From: Adams, Norvella
Sent: Monday, July 21, 2008 3:53 PM
To: 'Jones, William V., EMNRD'
Subject: RE: Injection Application from Devon: Federal T #1 30-015-26404 Unit A Sec 12 T18S R27E
Attachments: Federal T #1_Proposed Schematic.pdf

From: Jones, William V., EMNRD [mailto:William.V.Jones@state.nm.us]
Sent: Wednesday, July 16, 2008 11:28 AM
To: Adams, Norvella
Cc: Ezeanyim, Richard, EMNRD; Warnell, Terry G, EMNRD; Phillips, Dorothy, EMNRD
Subject: Injection Application from Devon: Federal T #1 30-015-26404 Unit A Sec 12 T18S R27E

Well Name: FEDERAL T #1		Field: NORTH ILLINOIS CAMP MORROW	
Location: 660' FNL & 990' FEL; SEC 12-T18S-R27E		County: EDDY	State: NM
Elevation: 3634' KB; 3618' GL		Spud Date: 6/28/90	Compl Date: 9/13/90
API#: 30-015-26404	Prepared by: Norvella Adams	Date: 7/17/08	Rev:

**PROPOSED SWD
L. Wolfcamp and Cisco**

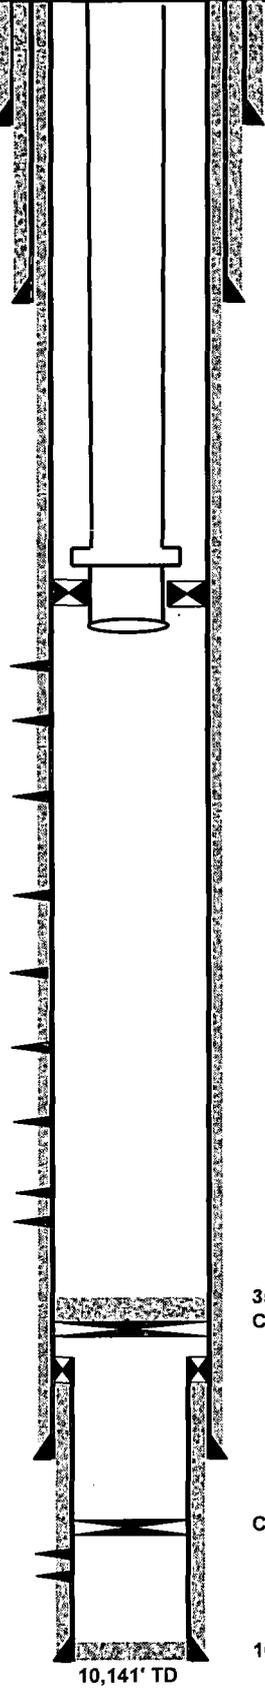
- 1) The Injection Data Sheet info has the wrong casing and cement sizes on it - I corrected this so it is OK now and is consistent with the wellbore diagram and the well file. **Thank you for correcting this. I could not find where I made the mistake if you have time would you please let me know so that I don't repeat the mistake.**

- 2) Send a "Post" conversion wellbore diagram - you can fax or mail it in. **Please see attached and you should receive one in the mail shortly.**
- 3) Please ask your landman (Mr. Gray?) to tell you specifically who the affected parties (Rule 701B(2)) are in these areas of the 1/2 mile Area of Review:

Good afternoon. Thank you for your initial review of our application. Please find below the answers to your questions and also a "Post" conversion wellbore schematic. I will mail the schematic to you as well. Please contact me should you need anything further or have any more questions or concerns.
